TO: Ryanne Sass, Plaza Street Partners
FROM: Stacey Nerger, Senior Planner
DATE: August 1, 2022
SUBJECT: Lincoln Professional Park – Preliminary Site Plan
Review Comments 04

LINCOLN PROFESSIONAL PARK FILING NO.1 PRELIMINARY SITE PLAN

LINCOLN PROFESSIONAL PARK FILING NO.1 PRELIMINARY SITE PLAN

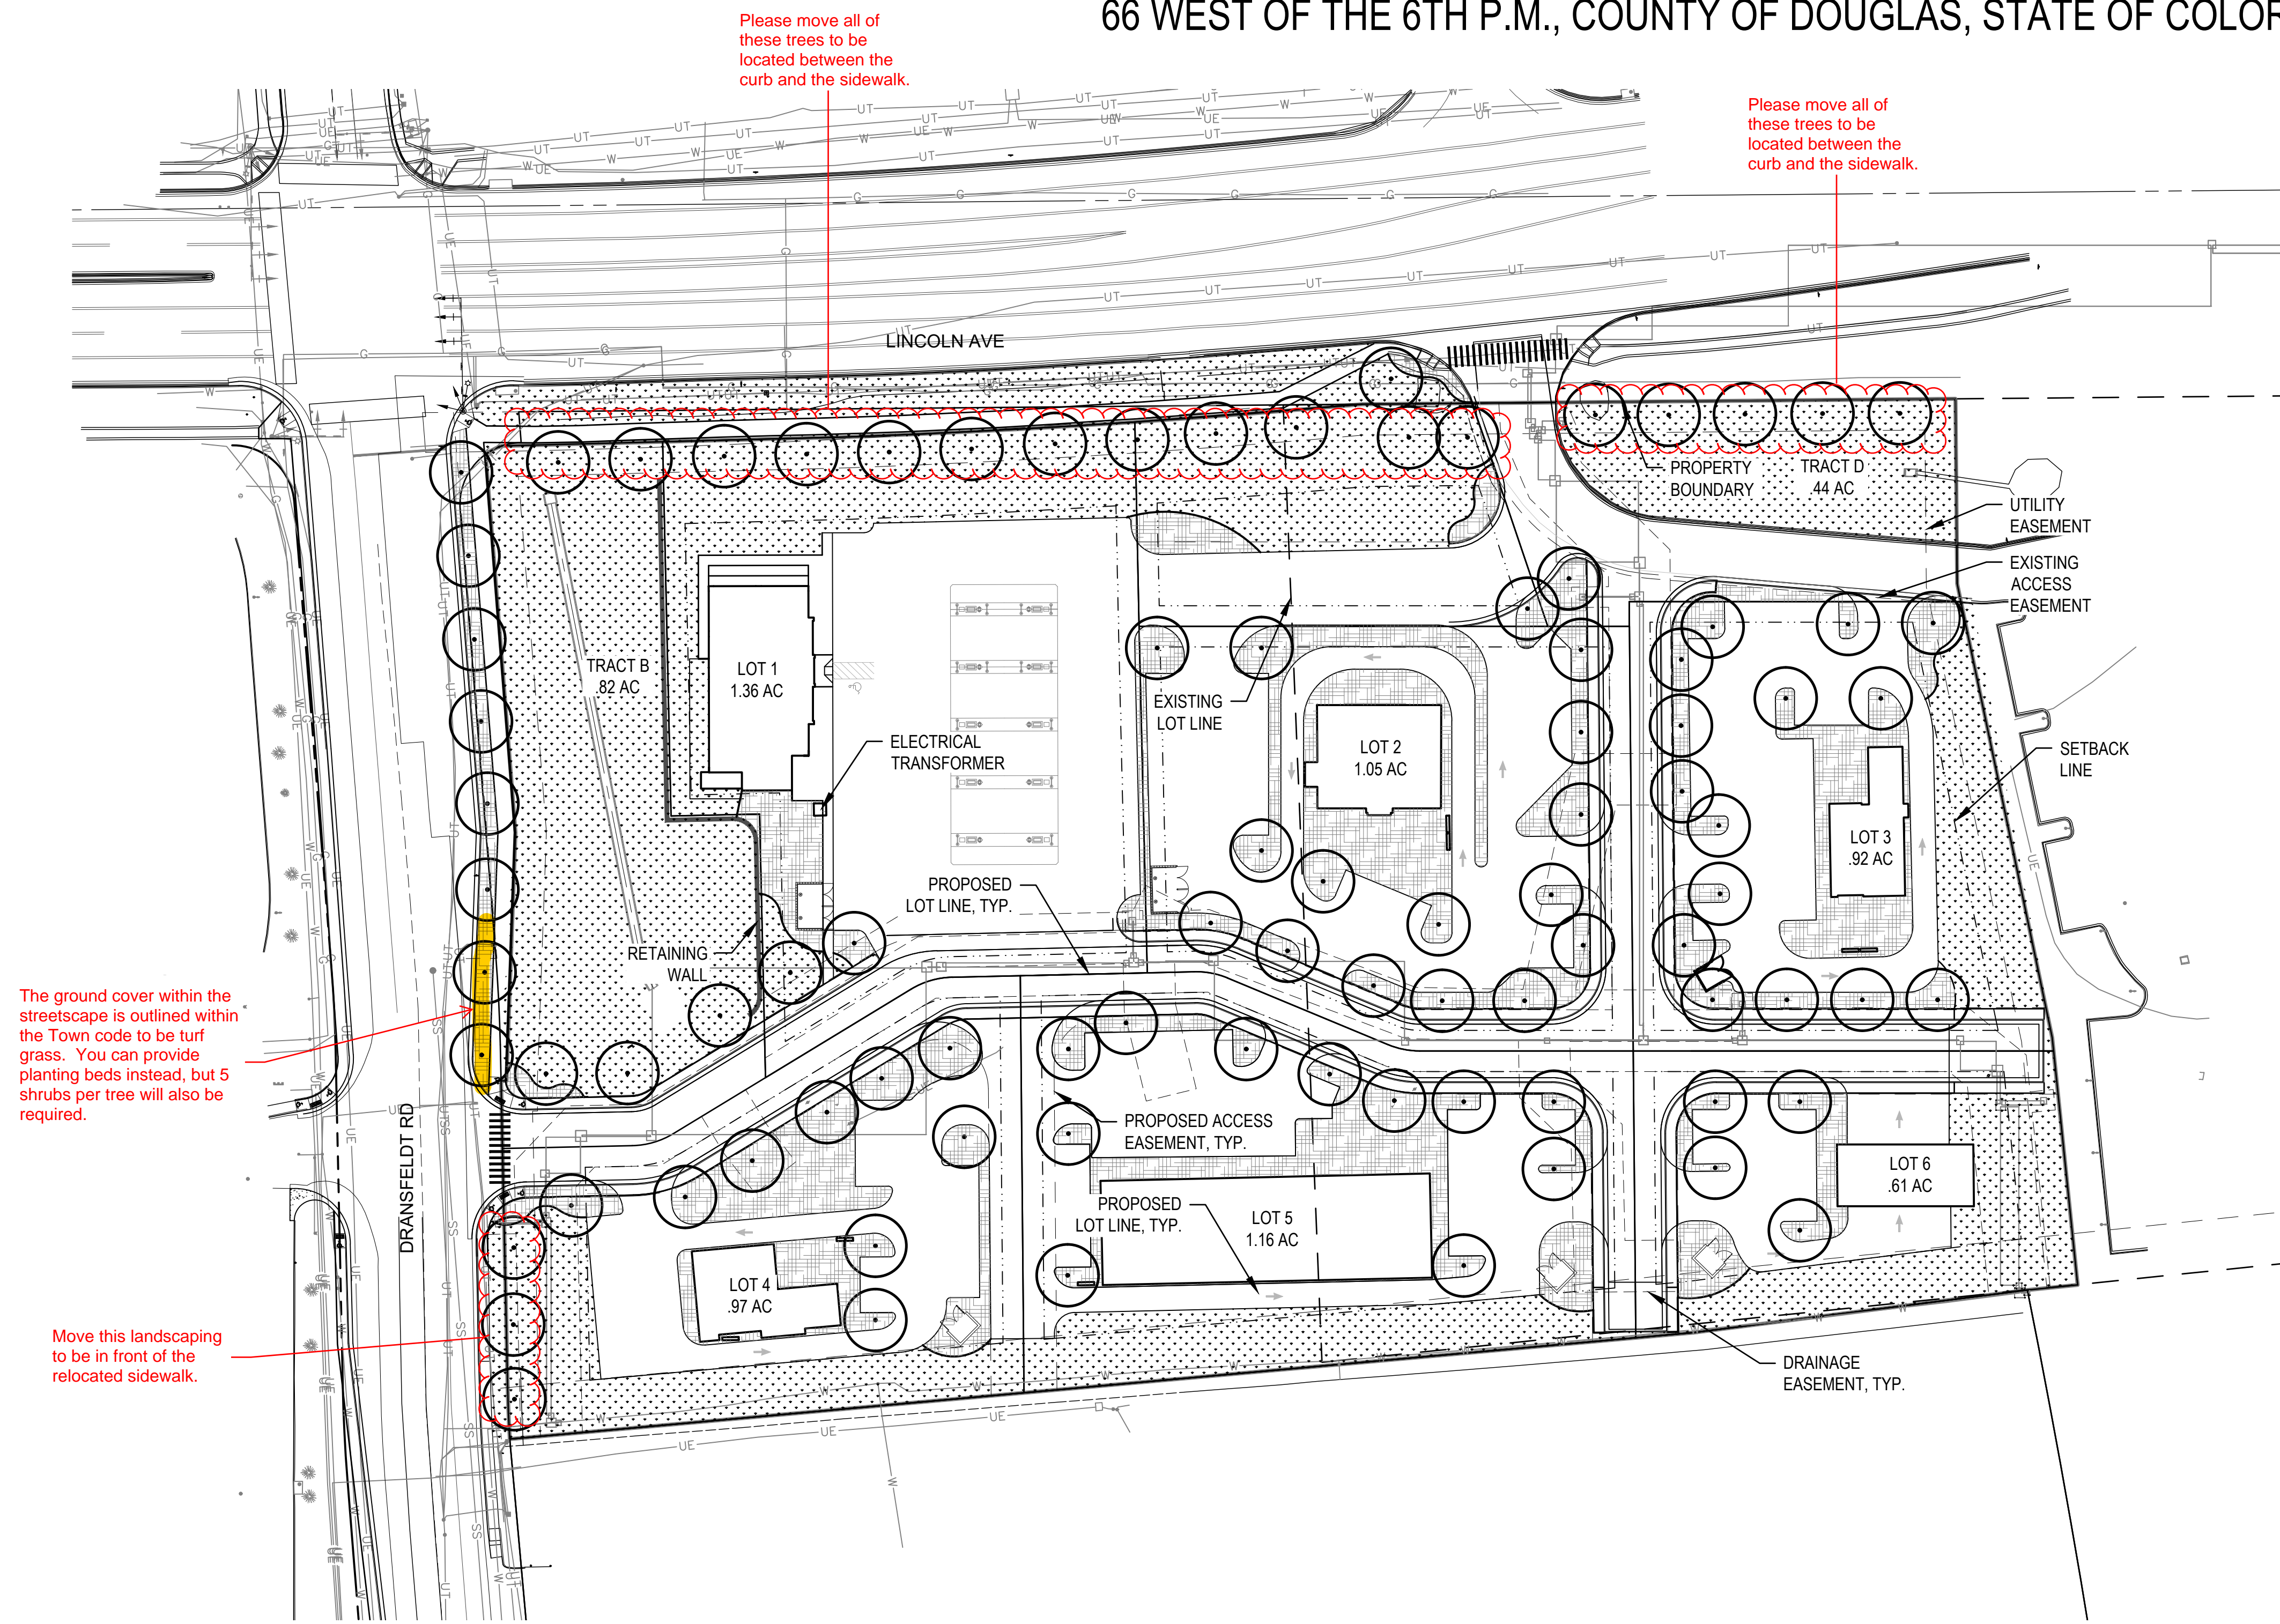
Please move all of these trees to be located between the curb and the sidewalk.

Please move all of these trees to be located between the curb and the sidewalk.

The ground cover within the streetscape is outlined within the Town code to be turf grass. You can provide planting beds instead, but 5 shrubs per tree will also be required.

Move this landscaping to be in front of the relocated sidewalk.

Within these calculations you can subtract the entrance and exits from the total number. For the internal roads, leave these as is since the entrance and exits into each property have not been determined and what is shown will most likely not be allowed due to spacing requirements.
